**Subject: Nuclear Metals, Inc. Superfund Site
Concord, Massachusetts
95% Remedial Design for In-Situ Sequestration of
Uranium in Overburden within the Holding Basin**

**Responses to Comments Received January 18, 2024 on the
30% Remedial Design Report for In-Situ Sequestration of Uranium within the Holding Basin**

April 2023 Groundwater Elevations and Uranium Concentrations in Overburden

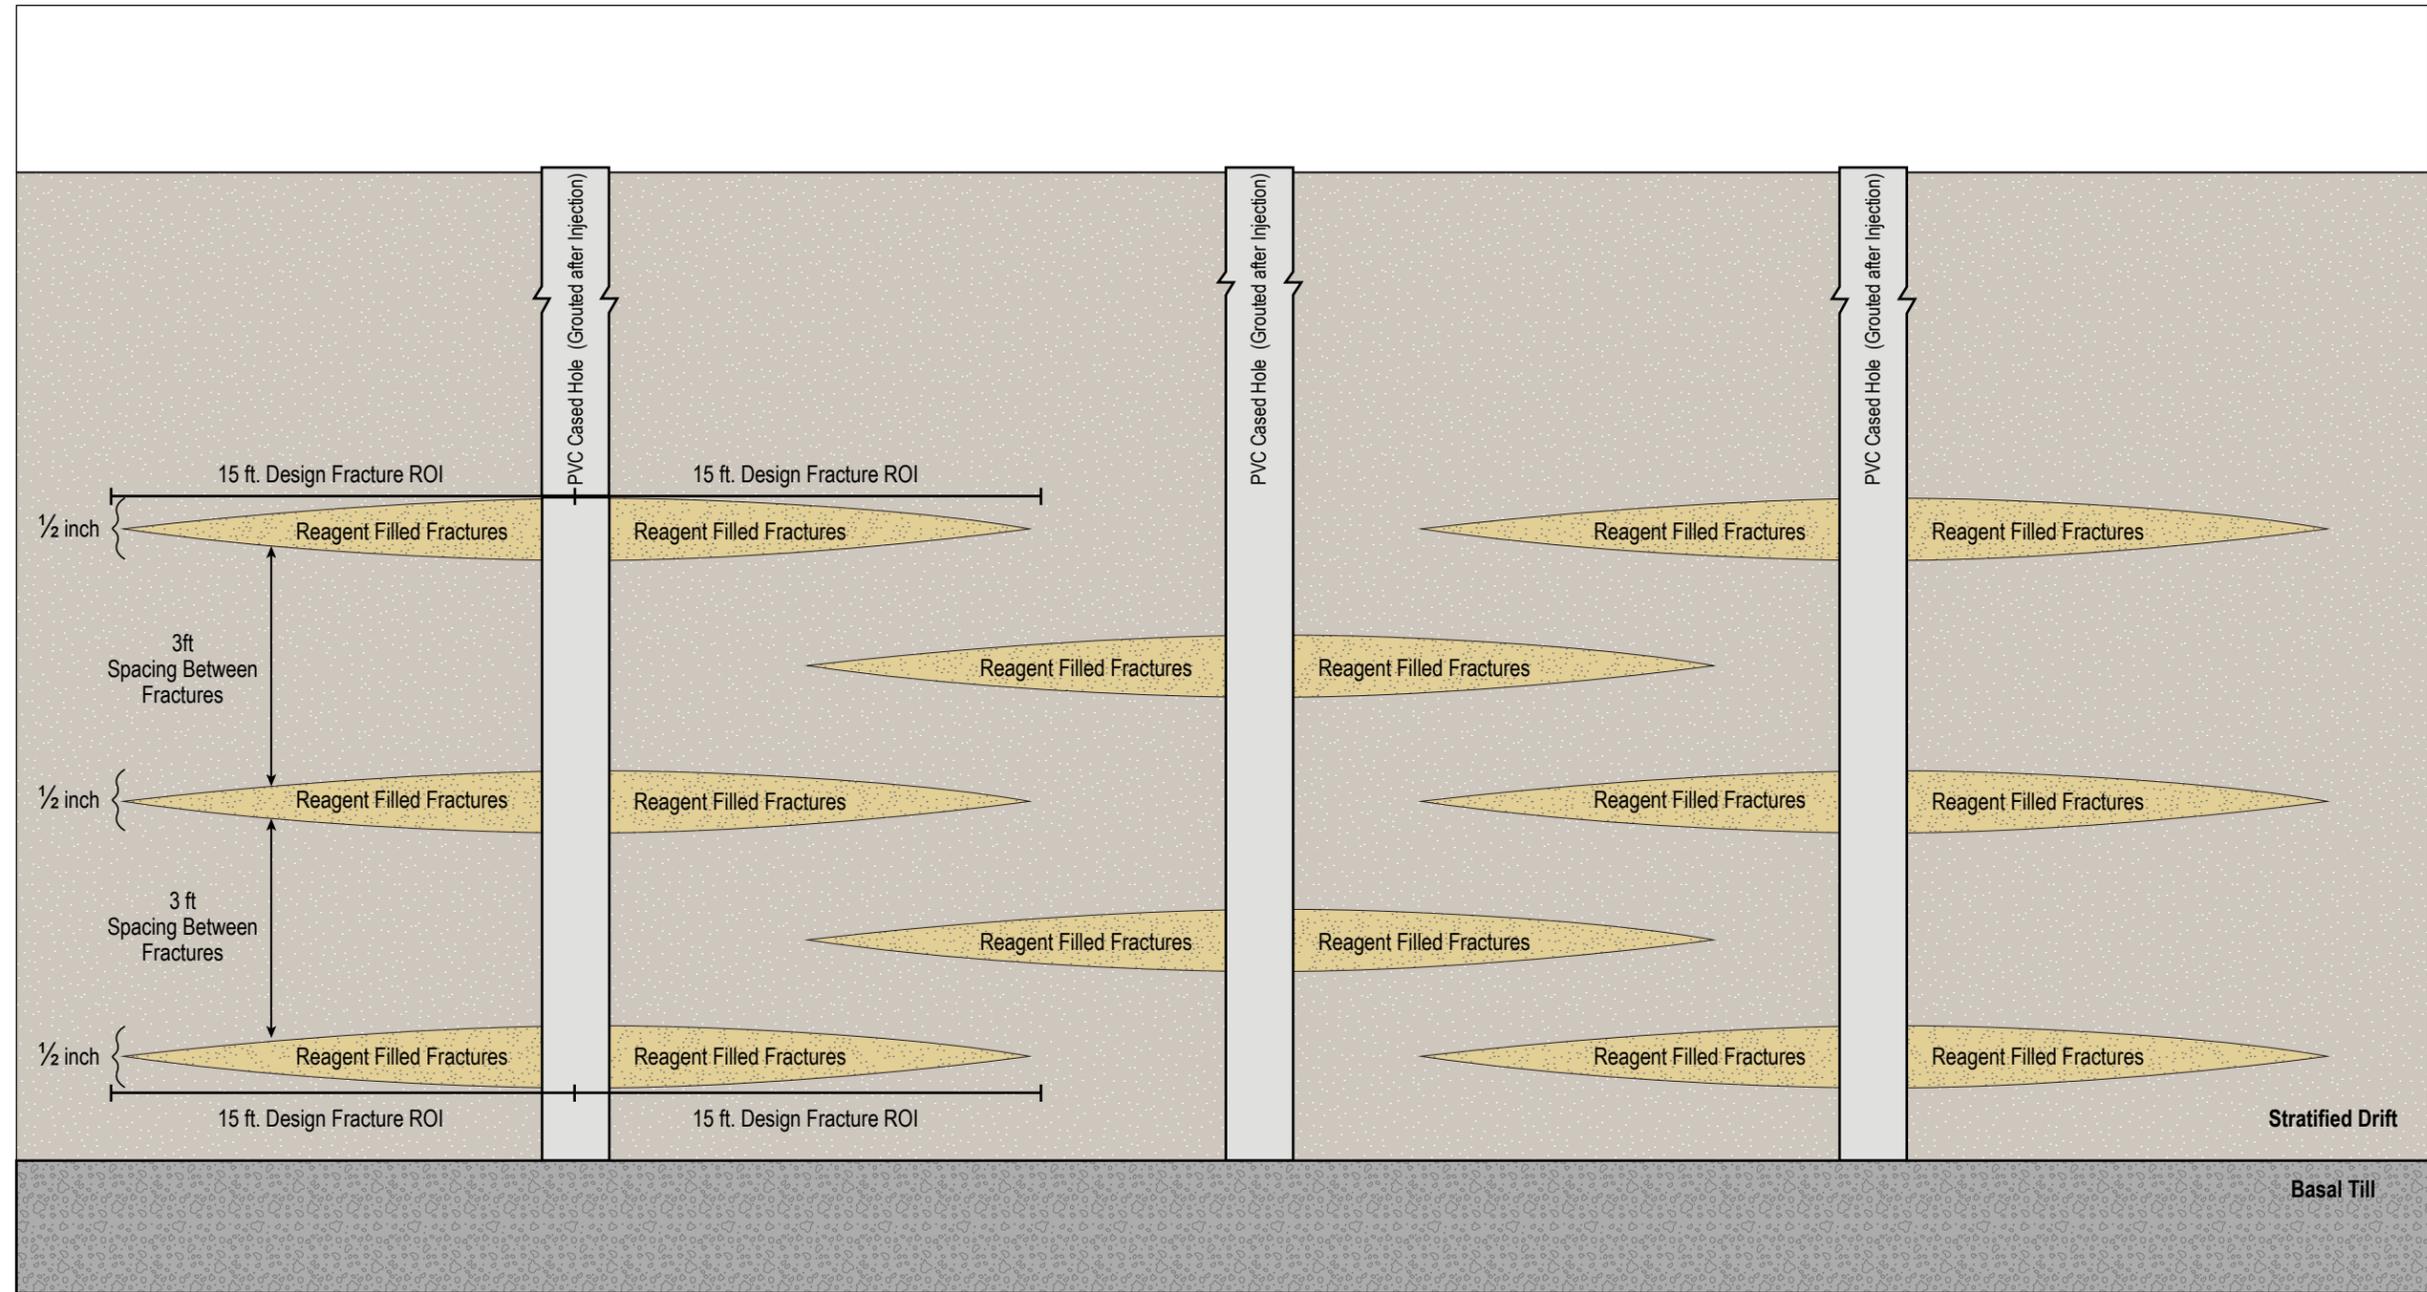
- 5) Figure 2 – April 2023 Groundwater Elevations. The groundwater elevations appear to reflect a groundwater divide in the vicinity of MW-S18 east of the holding basin. What is the reason for this. Is it an artifact of the contouring program.

Response: The area around MW-S18 has historically been a local groundwater elevation high point (see groundwater elevation contours in Annual Monitoring Report submittals). This area is upgradient of the HB, and uranium concentrations in groundwater are below 30 ug/L, so this is not relevant to this design.

1 CASED-HOLE CONSTRUCTION DETAIL

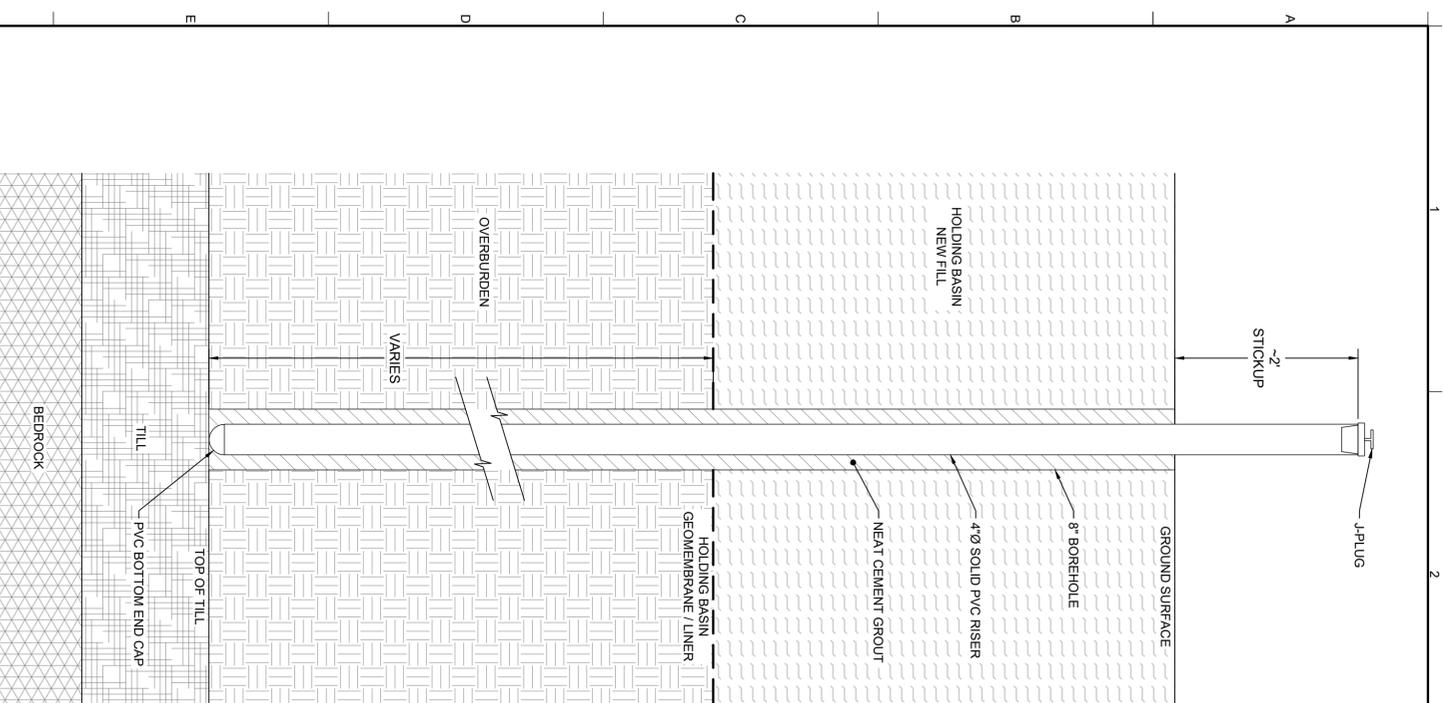
16. Drawing 7. Please clarify if it is necessary to tremie cement grout in place. If it was tremied in the pilot test, then it is recommended this technique be used during the ISS. Please edit the drawing as necessary.

Response: A note has been added to the detail for case-hole construction specifying that casing installation and grouting shall follow SOP-GW-003. The SOP specifies use of a tremie pipe and has been cited, instead of just describing tremie placement, because the SOP also contains other helpful construction information for the driller.
